ADD2021-00150 Lee County ePlan

ADMINISTRATIVE AMENDMENT
LEE COUNTY, FLORIDA

WHEREAS, Mark Brumfield, DR Horton filed an application for an administrative amendment to a Mixed Use Planned Development on a project known as Bentley Crossing to relocate required open space and indigenous open space areas based on an updated FLUCCS map for the property located at 7341, 7350, and 7990 Buckingham Road, described more particularly as:

BENTLEY
CROSSINGS
MIXED USE
PLANNED
DEVELOPMENT

MASTER
CONCEPT PLAN

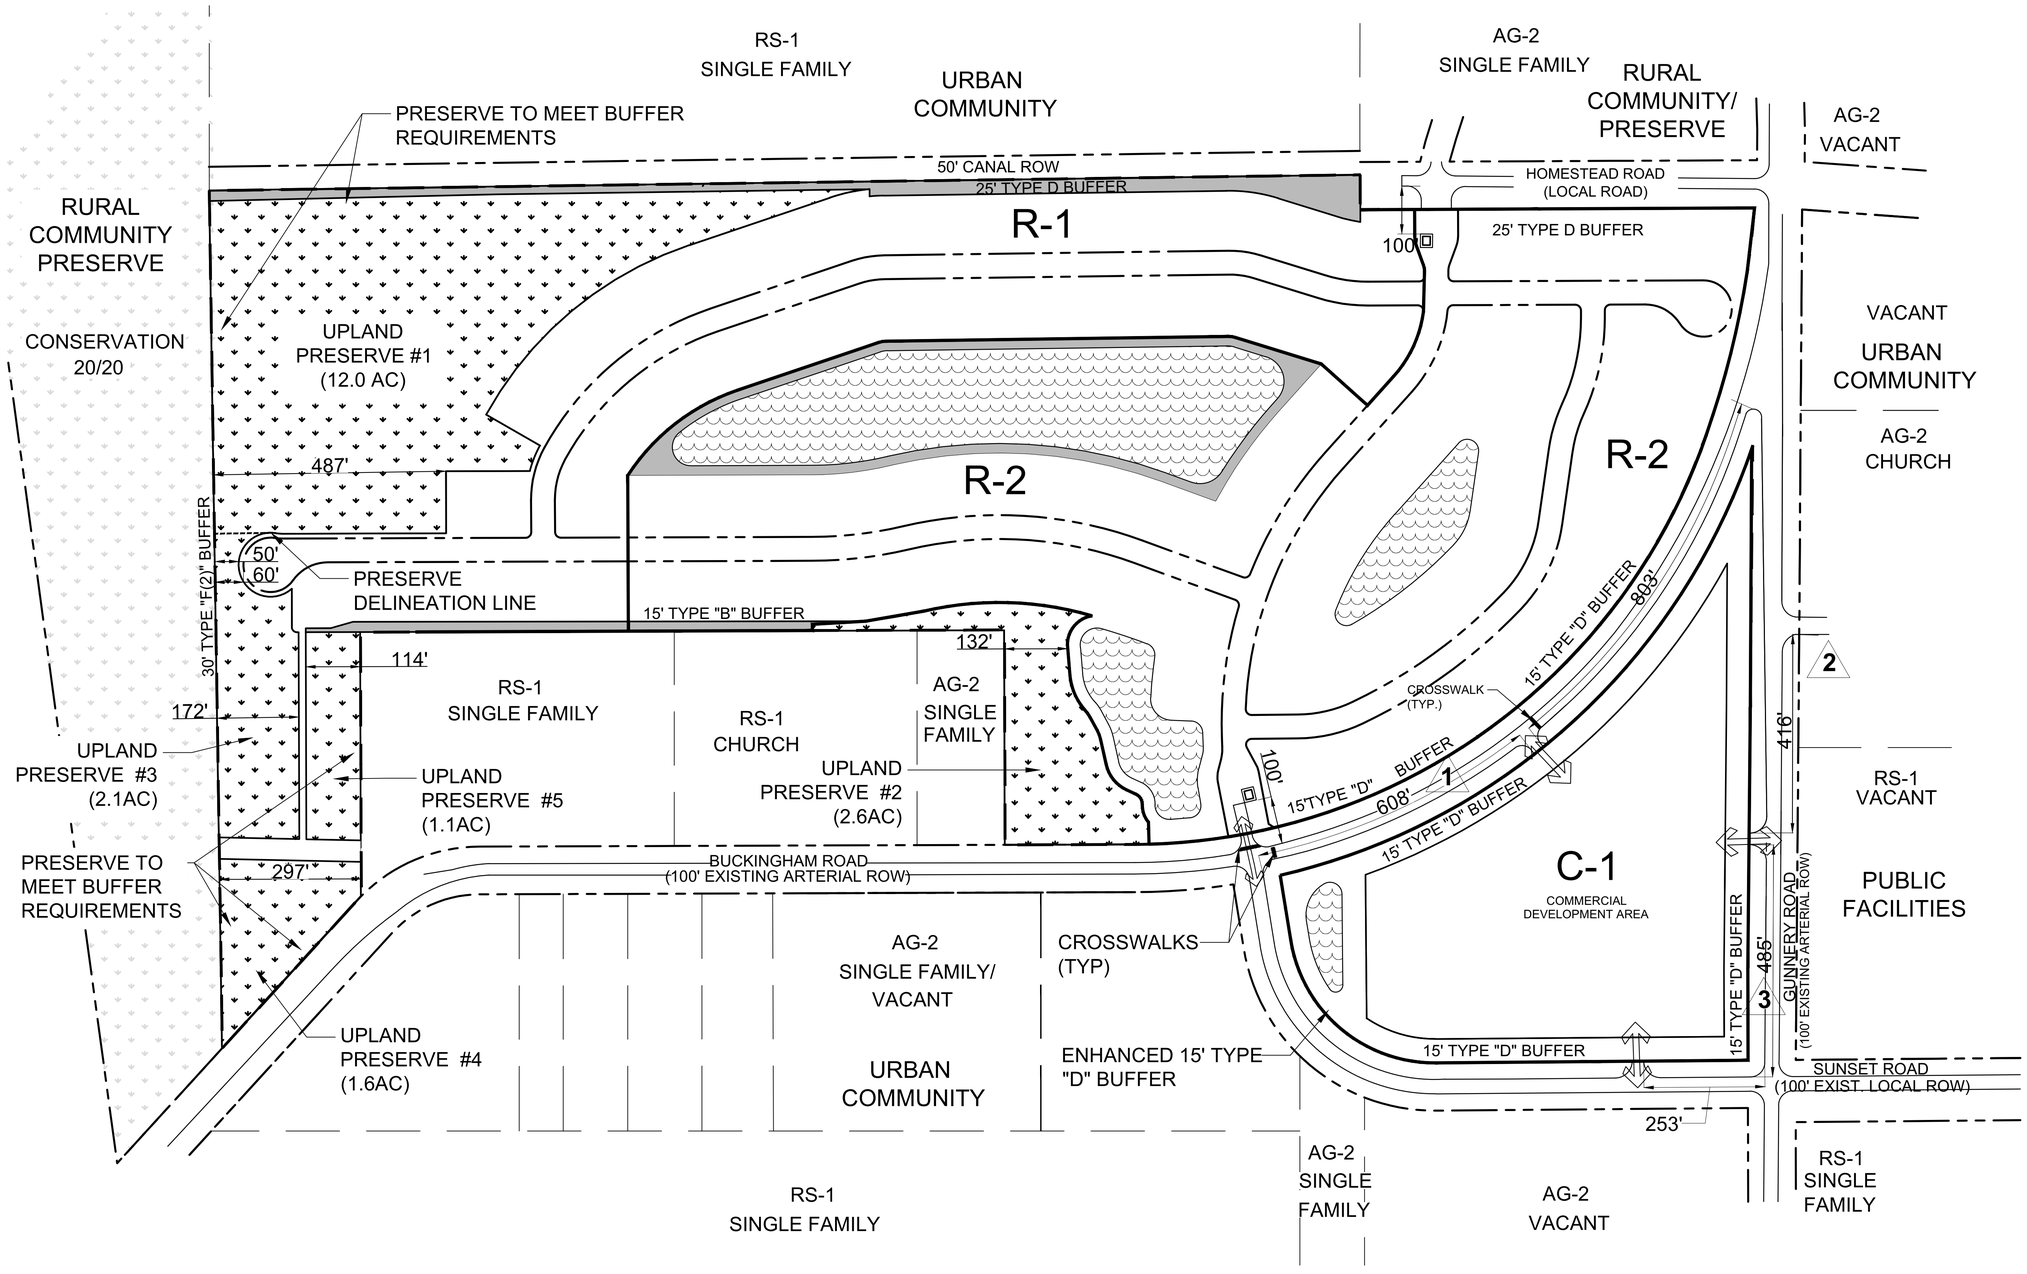
WHEREAS, the applicant is proposing a revised MCP included as Exhibit "B", that depicts the proposed overall open space and indigenous open space modifications; and

WHEREAS, areas previously designated as indigenous open space no longer meets the definition to be classified as such based in the most recent FLUCCS map; and

WHEREAS, the total indigenous open space and overall open space is not being reduced by more than 10% of the required area; and

1. **The Development must be in compliance with the amended Master Concept Plan, dated October 20, 2021, a reduced copy of which is attached hereto as Exhibit "B."**

7 8 INTERNAL ROAD N.T.S.

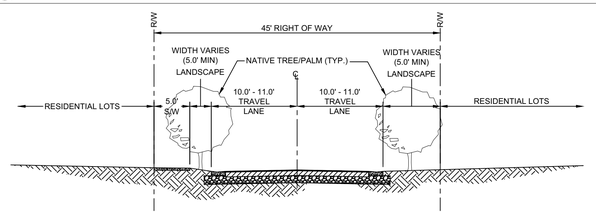
WHEREAS, the proposed Master Concept Plan provides a typical cross section depicting the proposed internal roadway design (see Exhibit "B"); and

WHEREAS, the applicant proposes to amend Condition 18 of Resolution Z-15-015 to ensure consistency with the cross section depicted on the Master Concept Plan and to incorporate Condition 30 of Resolution Z-15-015 for ease of administration (see Exhibit "G"); and

WHEREAS, the modifications to Condition 18 of Resolution Z-15-015 clarify the number and type of shade trees proposed along the internal roadway consistent with the cross section depicted on the Master Concept Plan and the requested deviation from LDC Section 10-296; and
